**SUNDRY NOTICES AND REPORTS ON WELLS**

8. FARM OR LEASE NAME  
Navajo Tribal H

9. WELL NO.  
7

Attachment to Notice of  
Intention to Abandon

NAVAJO H7  
TOTAL GALLUP

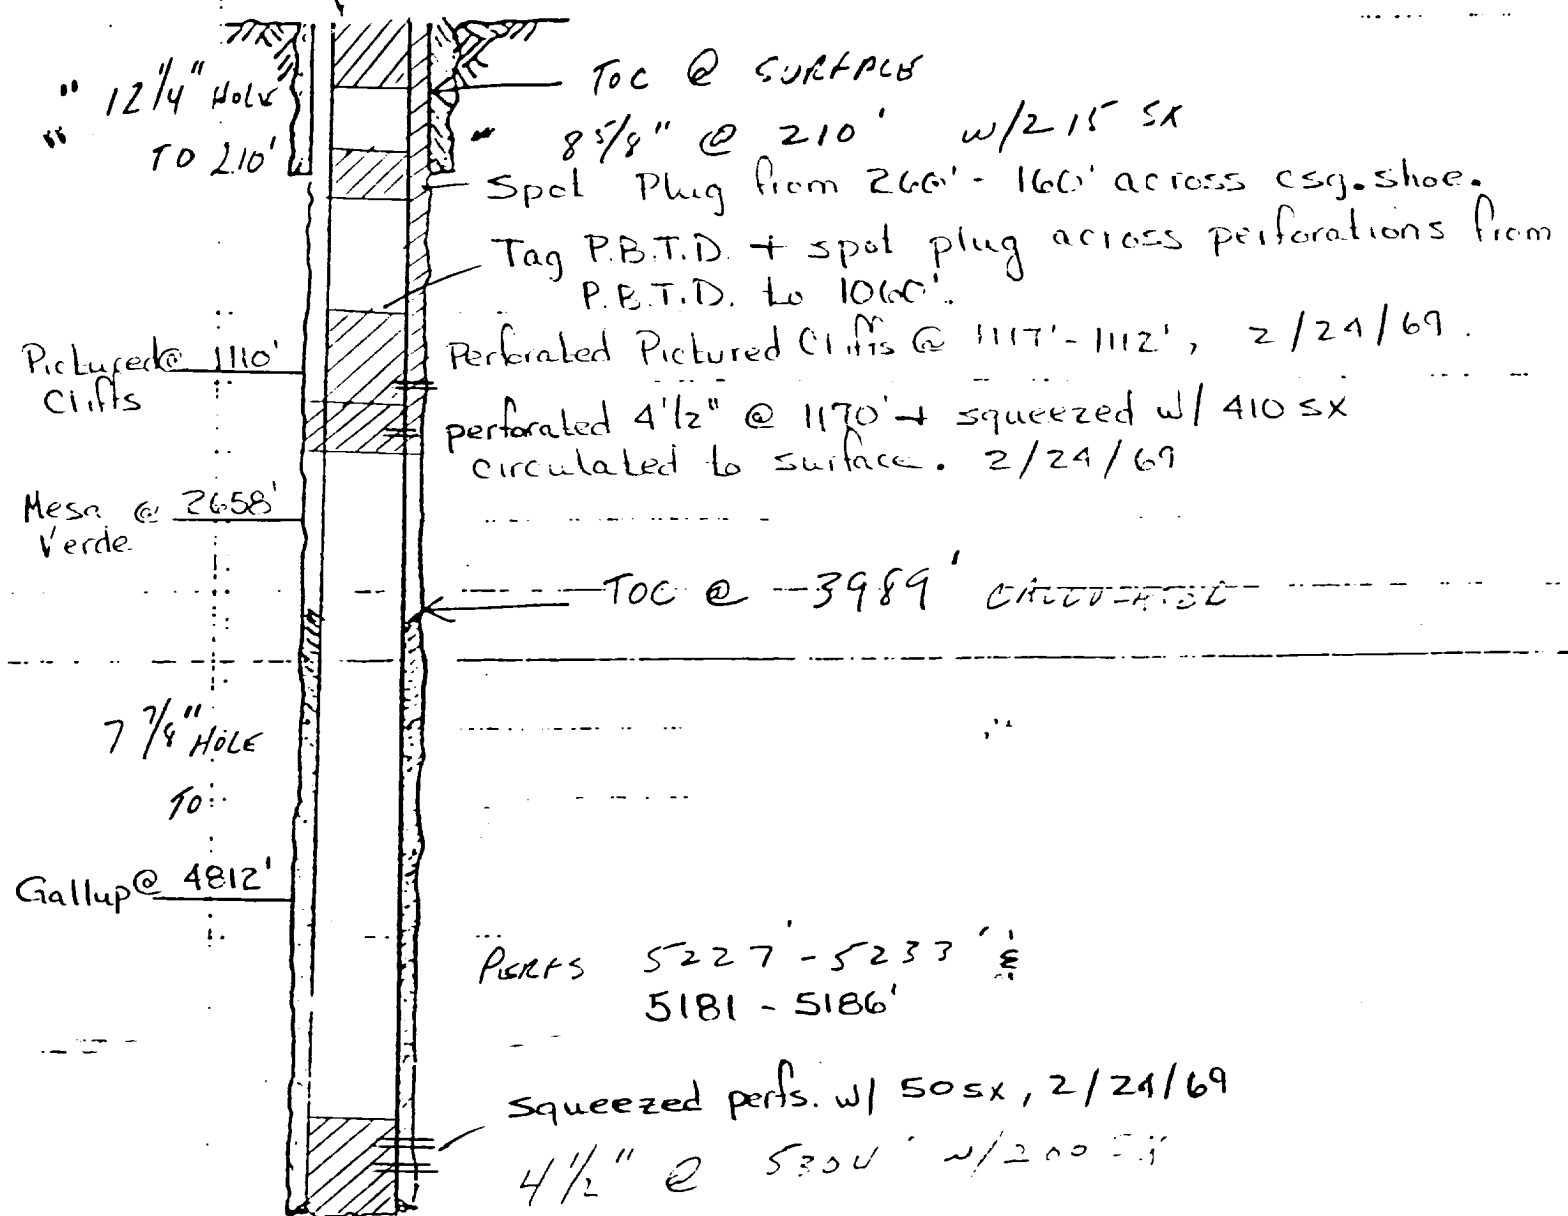
5. The following modifications to your plugging program are to be made (when applicable):

- 1) Tag P.B.T.D. + spot plug across perforations from P.B.T.D. to 1060'.
- 2) Spot plug from 260' - 1160' across csg. shoe.
- 3) Spot surface plug from 100' - surface.

Spot surface plug  
from 1065' - surface.
